**Prairie Island Nuclear Generating Plant**  
1717 Wakonade Dr. East • Welch MN 55089

**Prairie Island Nuclear Generating Plant Response to Draft NRR Position on  
TIA 2001-02, "Design Basis Assumptions for Non-Seismic Piping Failure"  
(TAC Nos. MB1402 and MB1403)**

**Prairie Island Response to Draft NRR Position on TIA 2001-02  
"Design Basis Assumptions for Non-Seismic Piping Failure"**

Figure 1

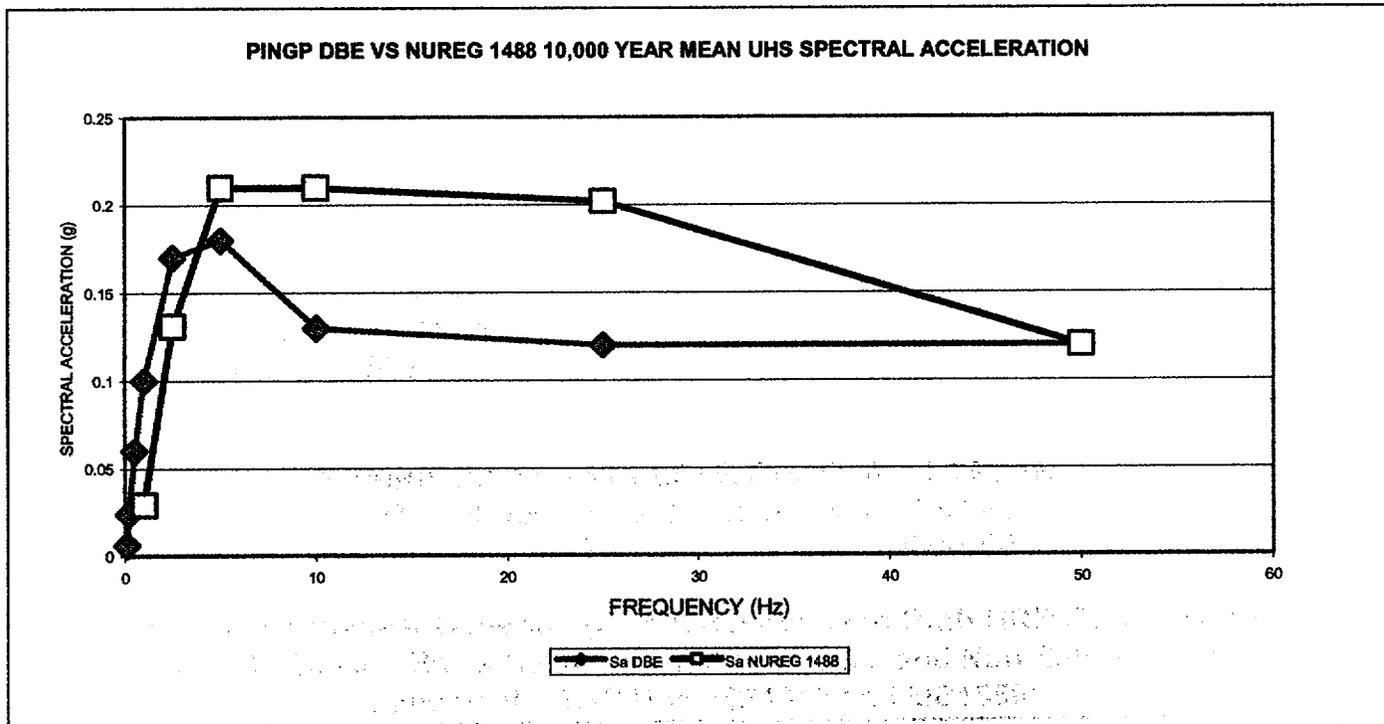
The DBE for Prairie Island is defined as a 0.12g Housner spectrum. The LLNL revised hazard studies in NUREG 1488 contain UHS for Prairie Island. In IPEEE, the mean UHS was recommended for use in determining a point estimate of seismic induced failure. The mean 10,000 year return period pga from NUREG 1488 is 0.12 g for Prairie Island, corresponding to the 0.12g DBE. The UHS has higher spectral accelerations than the DBE spectrum at higher frequencies, but exhibits much lower spectral displacement. Figure 1 compares the 5% damped PING DBE spectral accelerations to the 5% damped NUREG 1488 UHS spectral accelerations. At 5 Hz and above the UHS spectral acceleration is significantly higher than the DBE spectral acceleration, however the associated displacements are very small. Figure 2 plots the spectral displacement derived from the two ground motion acceleration spectra. At 1 Hz, the spectral displacement for the DBE is about three times that of the NUREG 1488 UHS. LLNL and EPRI did not define the UHS below 1 Hz; therefore a direct comparison cannot be made below this value. The very low frequency range of the DBE, at less than about 0.2 Hz, results in a maximum of about 6 inches of amplified spectral displacement. We don't expect any systems to be below 0.5Hz where the spectral displacement of the DBE is about 2.3 inches. The UHS, if extended below 1 Hz, would result in significantly less spectral displacement than this.

Figure 2

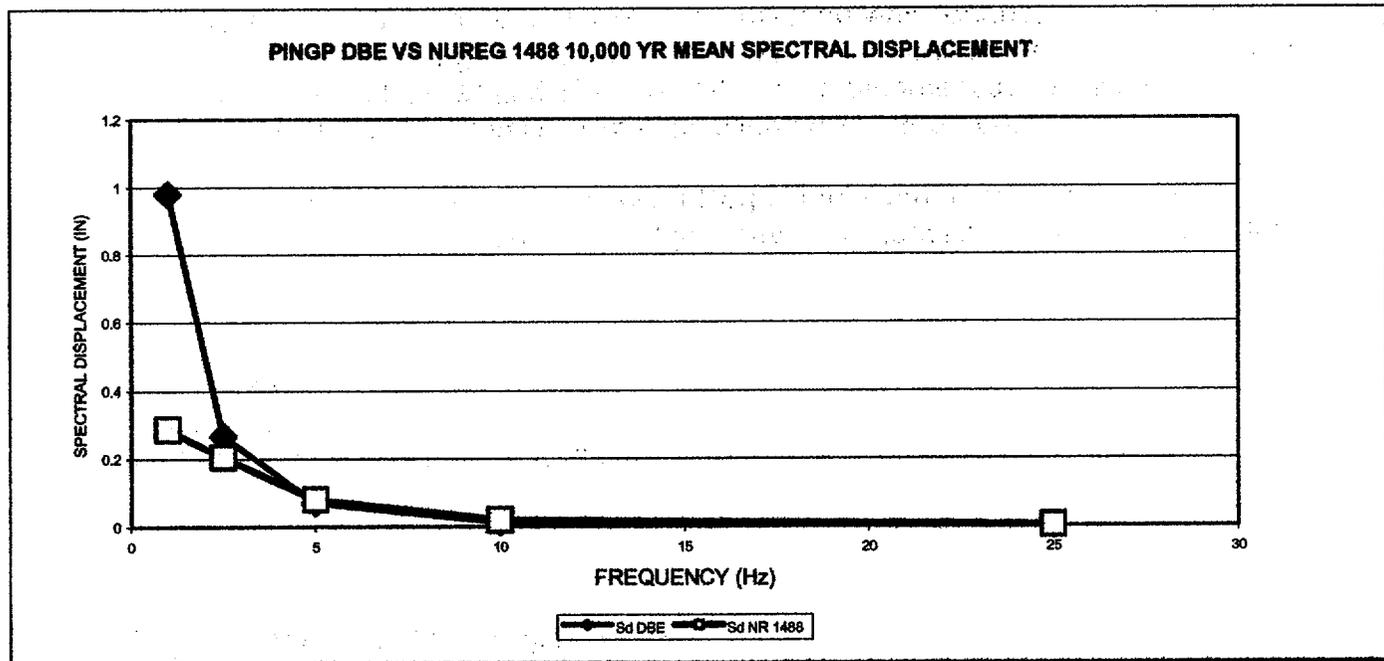
Piping systems not supported laterally for earthquakes typically have fundamental frequencies greater than 0.5Hz. The spectral displacement for the DBE at 0.5Hz is about 2.3 inches and would be expected to be 1/3 or less of this value for the NUREG 1488 UHS. Thus, lateral displacements of long unsupported spans of piping are realistically expected to displace less than 1.0 inch which can easily be accommodate in flexible piping with low frequency.
